**Meeting of the Central Valley Flood Protection Board  
April 24, 2015**

**Staff Report**

**California High Speed Rail Authority  
High-Speed Rail Bridge across Fresno River, Madera County**

- NOTES:**
- 1. WATSON ST TO BE CLOSED.
  - 2. FOR NOTES, SEE DRAWING NO. ST-J1100-FRV.
  - 3. IF DISTANCE FROM OG OR FG TO PILE CUTOFF IS 4'-6" OR LESS, AN ISOLATION CASING IS NOT REQUIRED.

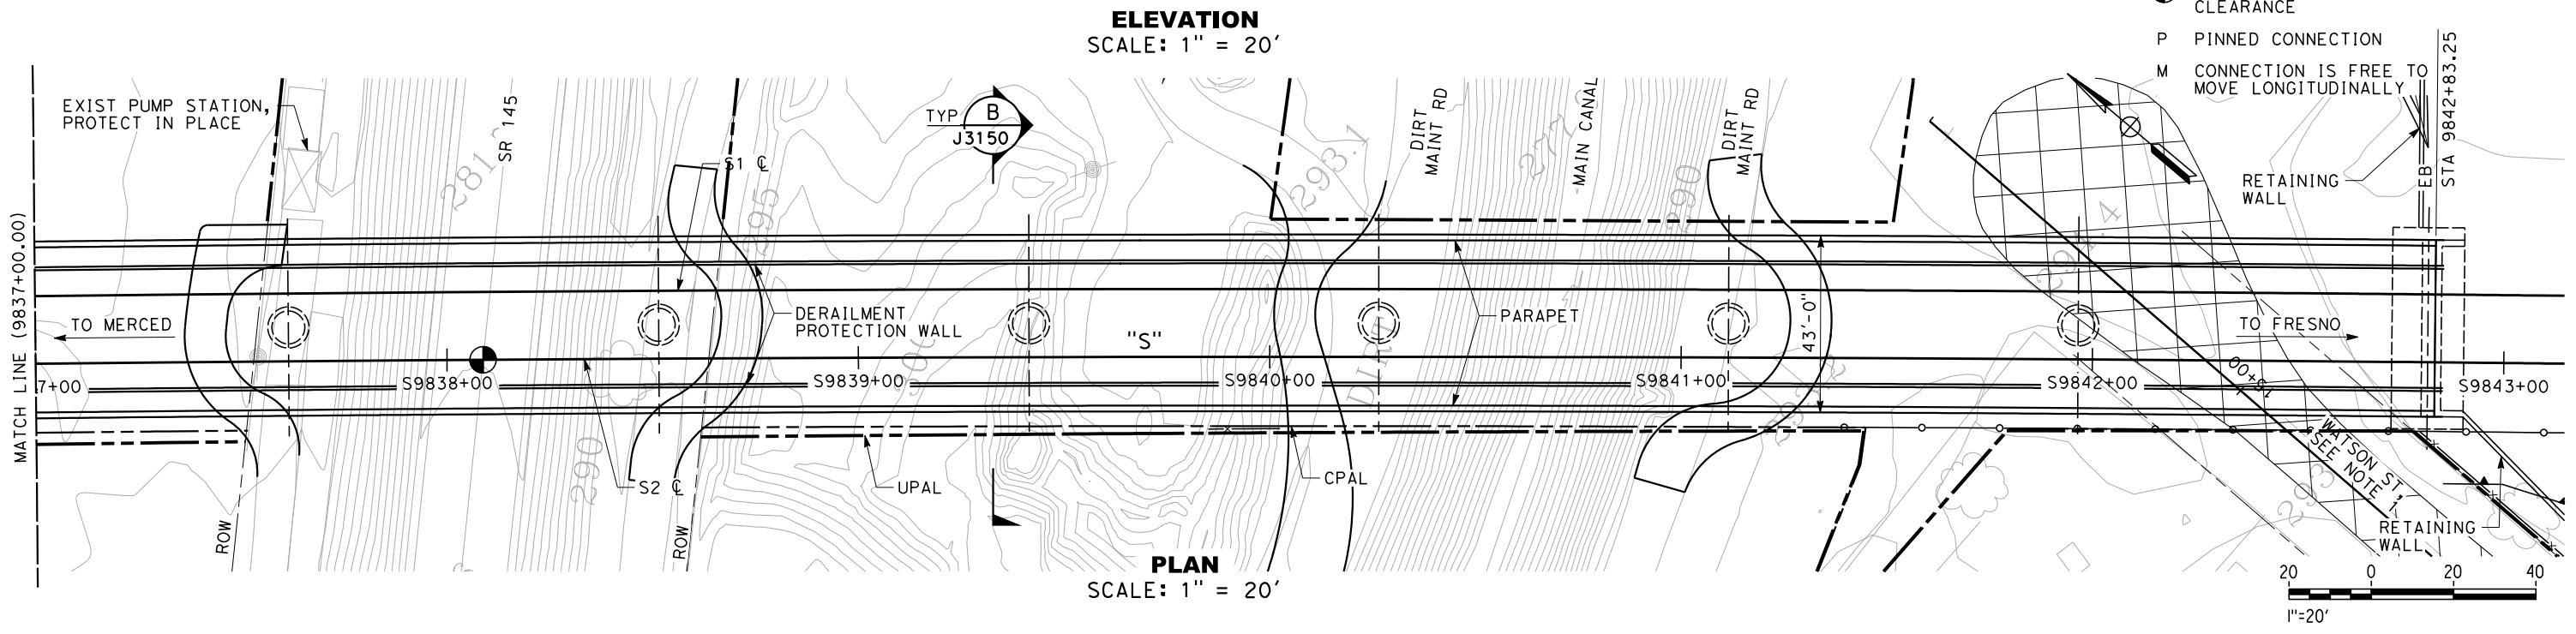
Even at the FEMA-established flow rate for the 500-year storm, the proposed HST bridge will provide 18.4 ft of freeboard. The structure will adequately meet freeboard requirement of passing the 200-year design discharge with 3 ft of freeboard.

The foundations of the piers and abutments should be installed below the estimated scour depths. Per the FHWA's HEC-18, the top of the pier footing should reference the thalweg of the channel and should be placed below the sum of the long-term bed elevation change and contraction scour. Based on the complex pier scour equations, in order to minimize the local scour, WRECO has determined recommended top of pile cap elevations for Bents B4, B5, and B6. The bottom of the pier footing should be below the total scour line. All piers were designed to the same elevation due to potential channel thalweg migration.
